**CITY OF BURIEN, WASHINGTON
MEMORANDUM**

SUBJECT: Addendum to Emerald Pointe on the Sound FEIS

In June 2008, the City of Burien issued a Final Environmental Impact Statement (FEIS) for the proposed Emerald Pointe Project. Access to the project analyzed in the FEIS was from SW 136th Street north across the adjacent Highline School District property to the site ("the 2008 plan" see Attachment 1). Subsequently, the applicant withdrew a request to obtain access rights across the School District property.

On May 21, 2009, the applicant submitted a revised access plan for the project ("the 2009 plan" see Attachment 2). Instead of entering through the School District property, the project access would be moved farther west along SW 136th Street, then directly north into the site. The purpose of this memo is to determine the appropriate environmental review needed for this proposed access revision.

Emerald Pointe EIS - Burien, WA
Figure 2.3-1 Site Plan: Alternative 2 - 178 unit

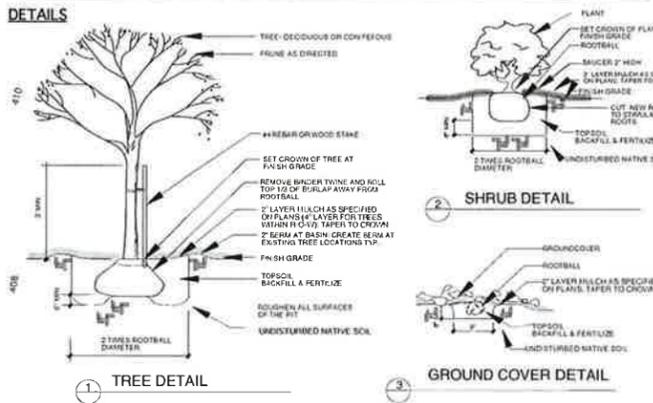
applicant. On July 23, 2009, the applicant submitted a plan (“the comparison plan” see Attachment 3) comparing the differences between the 2008 and 2009 plans. I subsequently requested additional information regarding the two areas I circled on the comparison plan. These areas would also change purpose as part of the 2009 plan—the northern circled area would become landscaping instead of road, and the southern circled area would be new road instead of landscaping.

The road alignment on the 2009 plan will be about 12' shorter than the 2008 plan. The 2008 road alignment is about 411' in length from a beginning point on SW 136th Street. The 411' is the total of the 396' written on the comparison plan and an estimated 15' of additional length in the northern circled area on the same plan. The 2009 road alignment is about 398' in length from the same beginning point on SW 136th Street. The 398' is the total of the 318' written on the comparison plan and an estimated 80' of additional length in the southern circled area on the same plan.

The 2009 plan will have 796 square feet less impervious surface than the 2008 plan. The comparison plan indicates that the 2009 plan will have approximately 3,612 square feet less impervious surface than the 2008 plan. These numbers were an estimate prepared by RW Thorpe & Associates. Subsequently, Touma Engineers submitted a more accurate calculation showing that the 2009 plan would have approximately 796 square feet less impervious surface than the 2008 plan.

The 2009 plan will involve less overall grading than the 2008 plan. The 2009 plan would require approximately 1,640 cubic yards of fill with little or no excavation. The 2008 plan would require approximately 1,833 cubic yards of excavation. Hillside stability was an impact addressed in the EIS. A December 16, 2009 letter from the City's geotechnical consultant on the project's EIS (PanGeo, see Attachment 4) concluded that the impacts of the 2009 plan would be less than the impacts of the 2008 plan since the new alignment would not require ground anchors to support cuts along the eastern property line and would be located in an area with more favorable ground conditions.

The 2009 plan will have shorter retaining walls than the 2008 plan both in height and in length. According to Touma Engineers (see Attachment 5), the 2009 plan will have walls of 2' to 8' high, with lengths of 110 feet along the north side and 120 feet along the south side of the road. The 2008 plan would have walls between 2' and 16' high, with lengths of 128 feet along the east side and 340 feet along the west side of the road.
